Enquiries: J Mans  
E-mail: [JacolineMa@daff.gov.za](mailto:JacolineMa@daff.gov.za)  
Date: 17 May 2016  
Ref: F13/11/2/311/1

**RE: COMMENTS ON FINAL SCOPING REPORT FOR THE PROPOSED HOUSING DEVELOPMENT ON PORTION 1 AND THE REMAINDER OF FARM SIMS 462, KATHU (DENC REF: NC/EIA/10/JTG/GAM/KAT2/2014)**

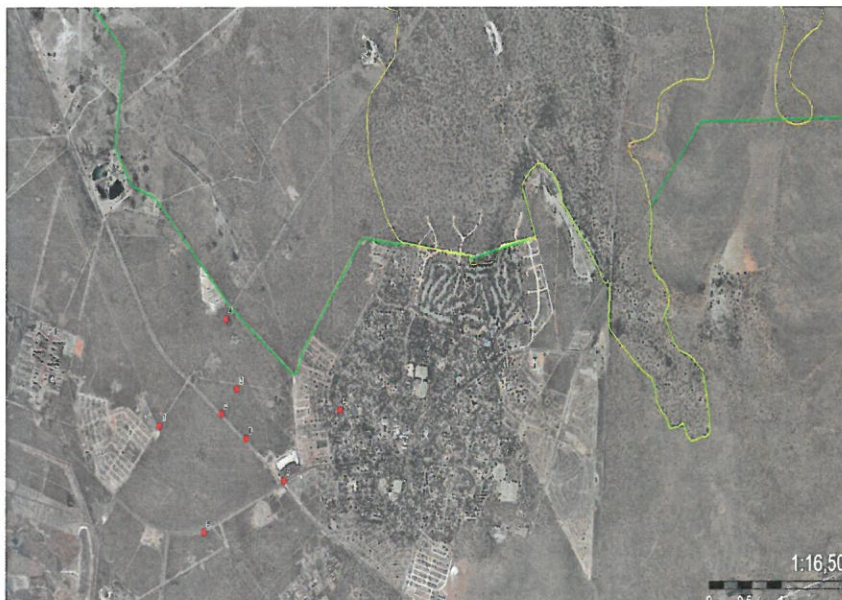
1. Page 24 of the report stated that the proposed development does not fall in the demarcated Kathu Forest. The DAFF agrees with the statement (see red dots below).
